THE CITY OF KEY WEST PLANNING BOARD
Staff Report

Meeting Date: October 25th, 2022

Application: **Major Development Plan – 700-724 Truman Avenue (RE #00030020-000000)** – A request for approval of a Major Development Plan and Landscape Waivers to renovate an existing building and convert approximately 15,187.21 SF of space into a high school on a parcel located within the Historic Public and Semi-public Services (HPS) zoning district pursuant to Section 108-91.A.2 and Section 108-517 of the Land Development Regulations of the Code of Ordinances of the City of Key West.

Overall Site Plan, submitted by the Applicant

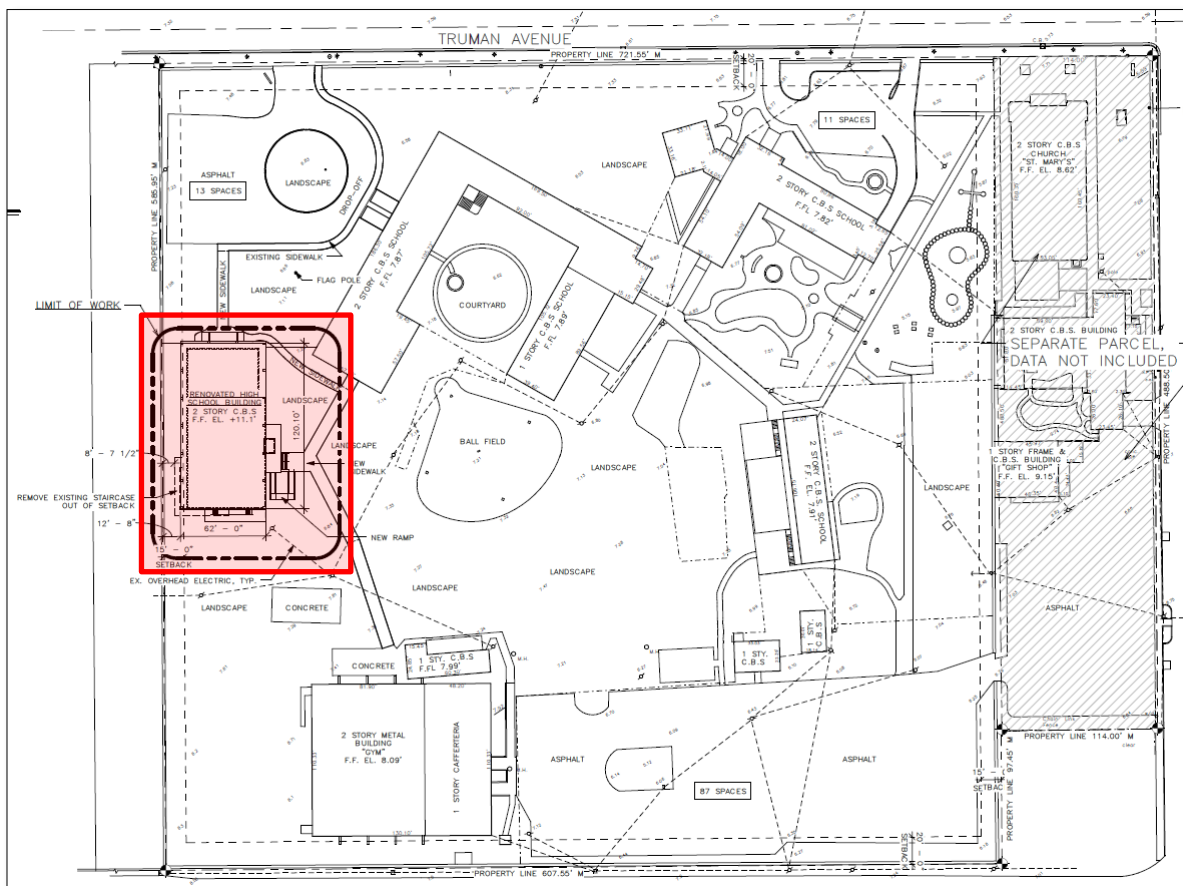
The overall site plan below shows the existing developments on the subject parcel. The area highlighted in red denotes the limits of the work area for the MDP request.
